BRUNSWICK STEAM ELECTRIC PLANT, UNIT NOS. 1 AND 2
DOCKET NOS. 50-325 AND 50-324/LICENSE NOS. DPR-71 AND DPR-62
REVISION TO PLANT EMERGENCY PROCEDURE

OPEP-02.6.28, "Off-Site Protective Action Recommendations," Revision 7:

***OFF-SITE PROTECTIVE ACTION
RECOMMENDATIONS***

REVISION 7

ATTACHMENT 1
Page 1 of 1
PAR Flowchart

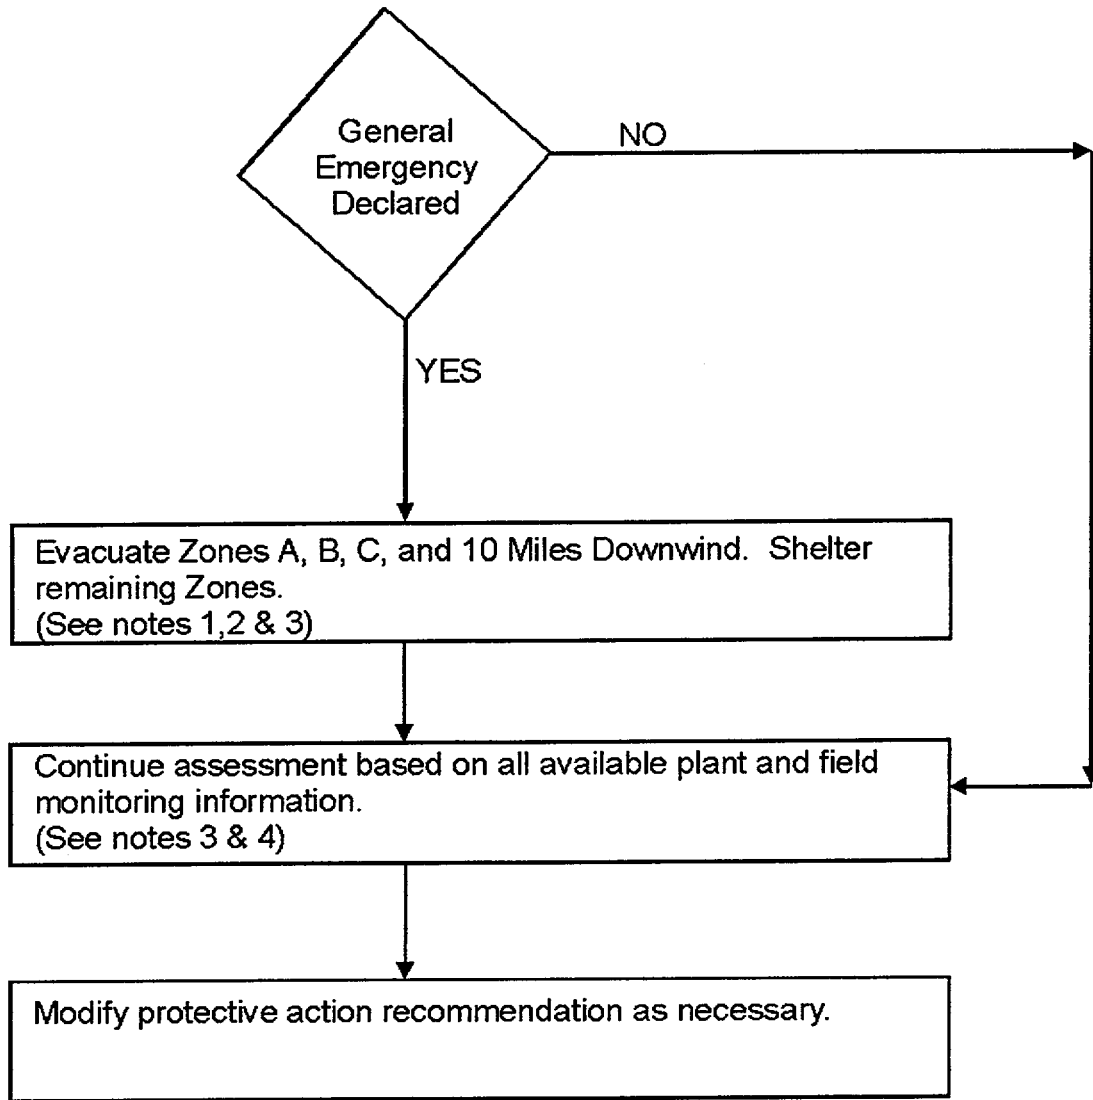
1. Revised Section 2.0 to add a reference to NUREG-0654, Revision 1, Supplement 3;
2. Clarified instructions for making initial Protective Action Recommendations (PARs); and
3. Revised Attachment 1, "PAR Flowchart," to be consistent with NUREG-0654 guidance.

- Revised references list to include NUREG-0654, Rev. 1 Supp. 3.
- Revised procedure section to direct making initial PAR based on Plant Conditions, consistent with NUREG guidance.
- Modified PAR logic diagram to be consistent with NUREG guidance.
